Comment Response Letter

Project Name: Alworth

Project Log Number: DSRFY2024-0003

The following in response to the Draft Staff Report dated December 27, 2023. Highlights are from the Staff Report.

ENLARGED
ELEVATION
A204
11/20/23 4:58:23 PM

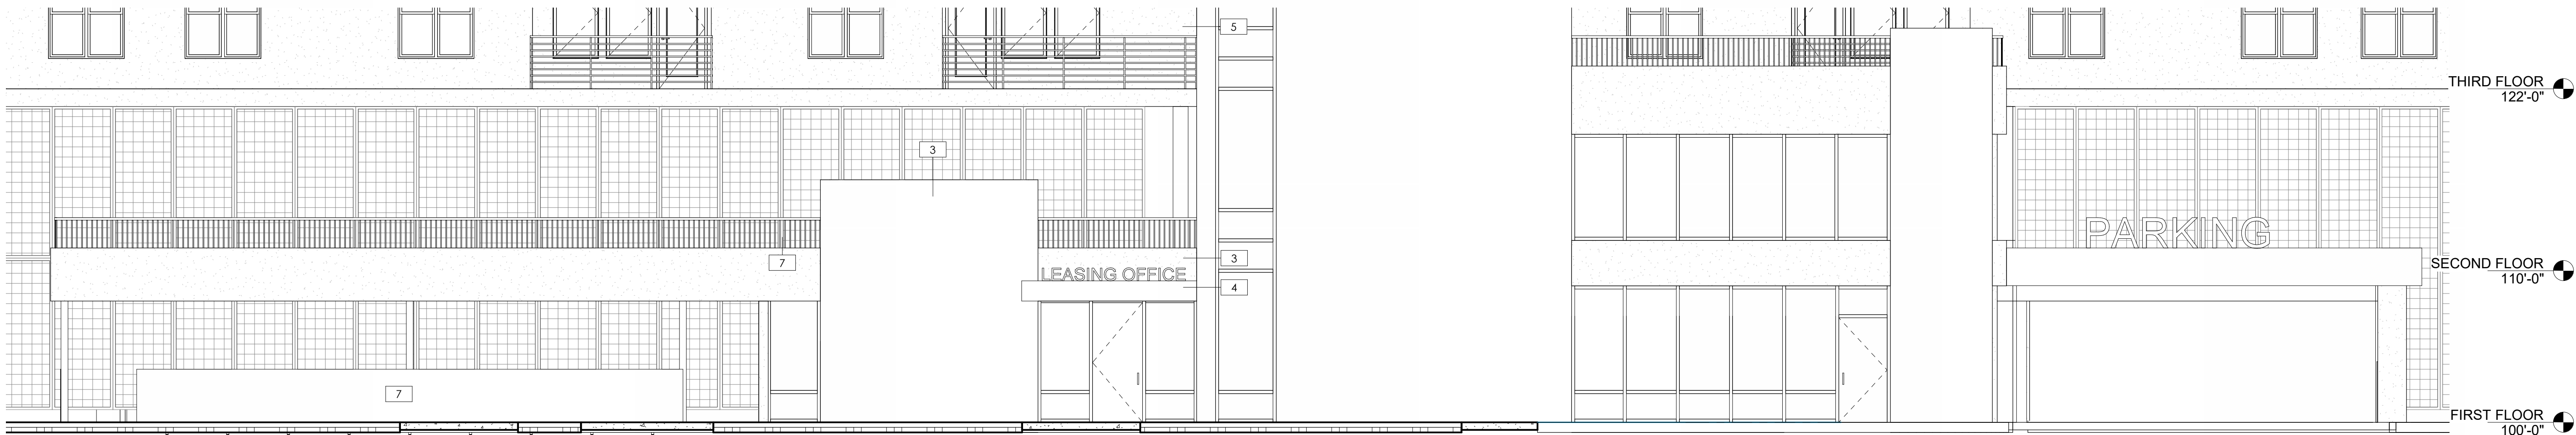
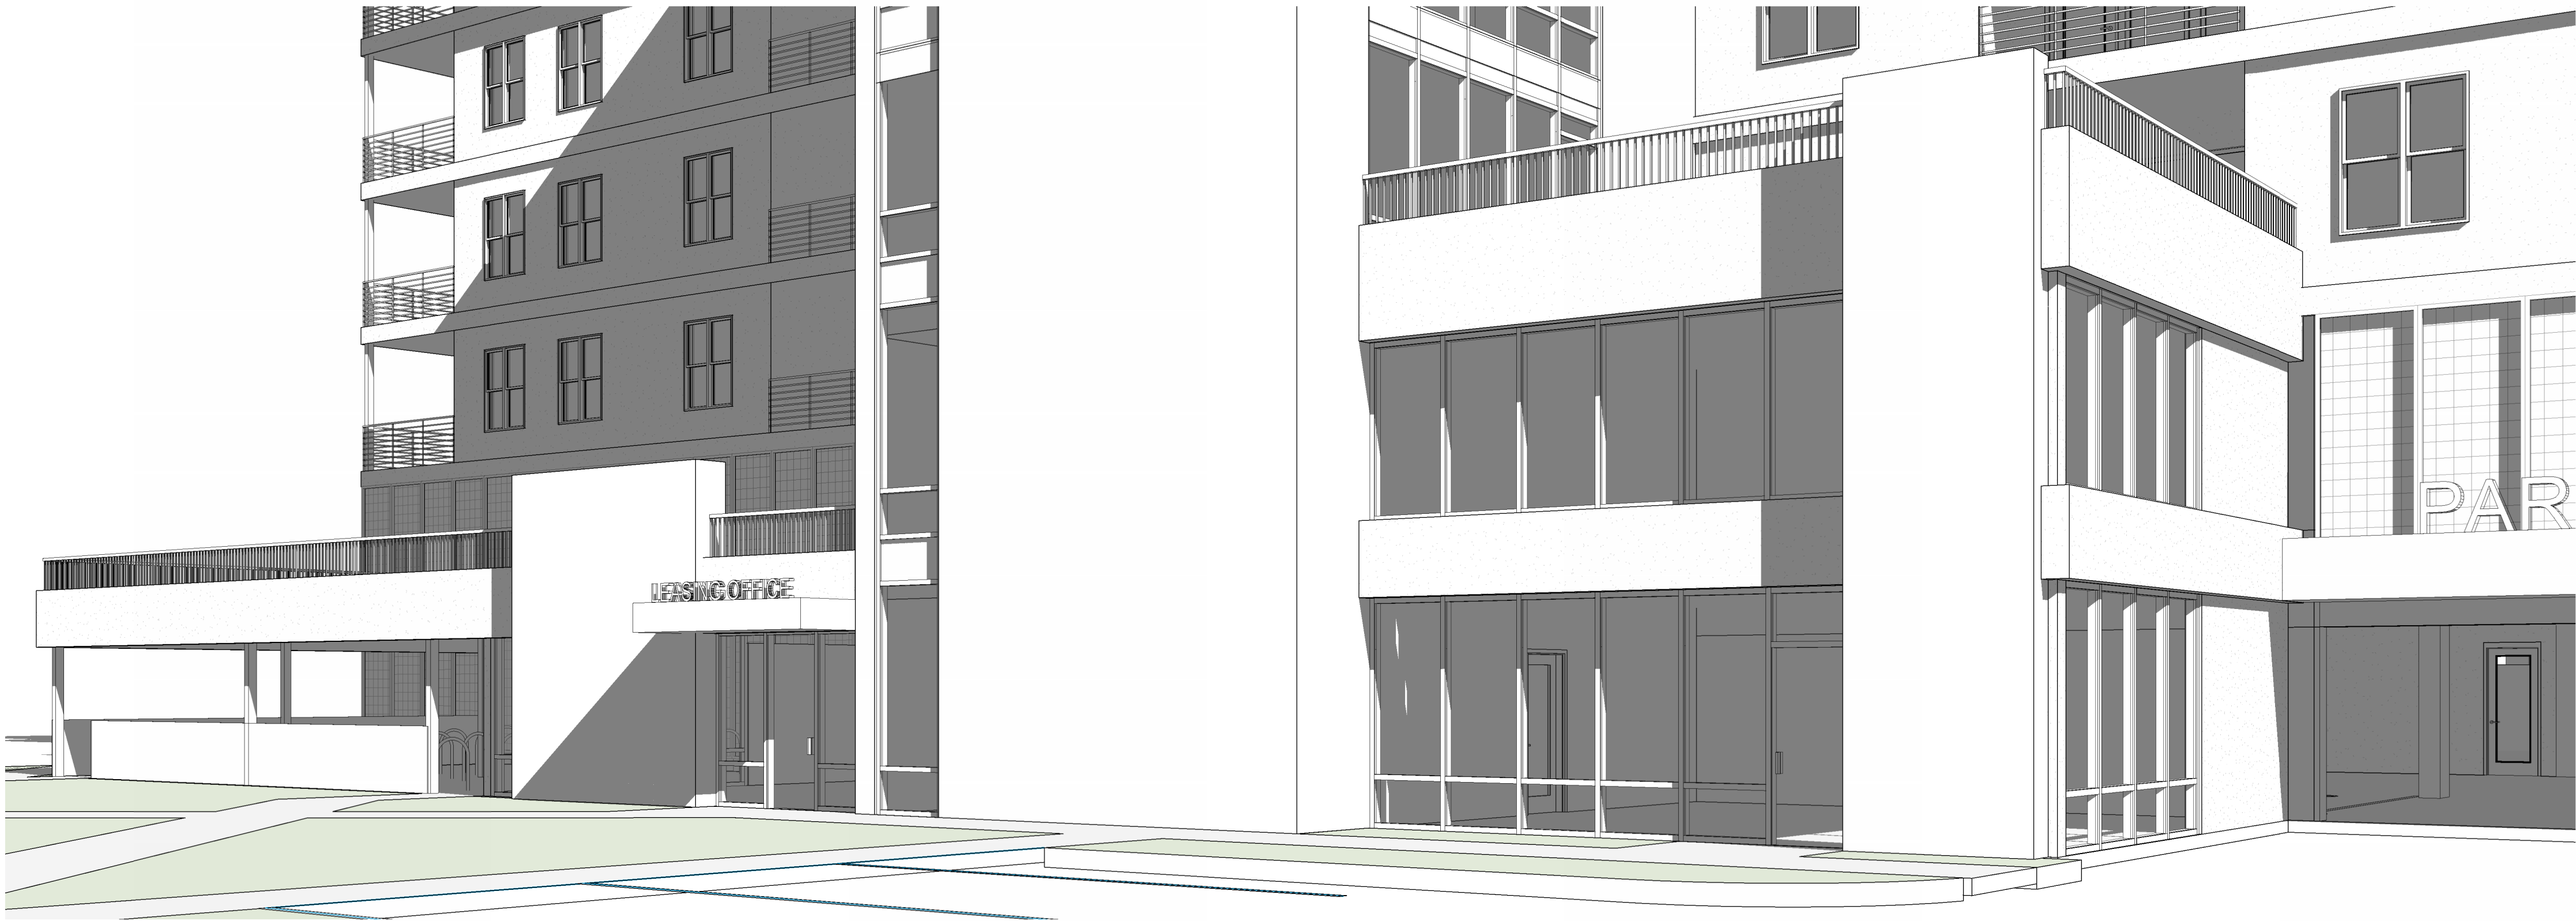
- b. Main entrances, which are the primary point(s) of entry where the majority of building users will enter and leave, shall be designed as an obvious entrance and focal point of the building through architectural treatment, lighting, and address identification. **Design Review Consultant's provided comments. The building does not appear to have a prominent enough main entrance.**

- c. Entrances shall be adequately covered, recessed, or treated with a permanent architectural feature in such a way that weather protection is provided. **Not identified. Resubmittals received on December 22, 2023, show new elevations as well as providing an explanation of the design. Discussion required.**

The front of the building was redesigned based on city comments, to eliminate pedestrian crossings of the drive aisle. With this modification, the front of the building was mirrored and the tenant entrance/leasing office shifted to the east side of the building, and the street facing corner. With this modification, the main entry was placed in a more prominent position and the design was tweaked to provide additional coverage at the entry, and a more prominent entry for the building. The main entry is also adjacent to a portion of blank wall that can serve for added signage under a separate permit. There is also a main entry for the tenant amenity spaces on the left side of the main stair tower, highlighted by large expanses of glass and covered by an aluminum awning. Refer to the added sheet A204 for additional information.
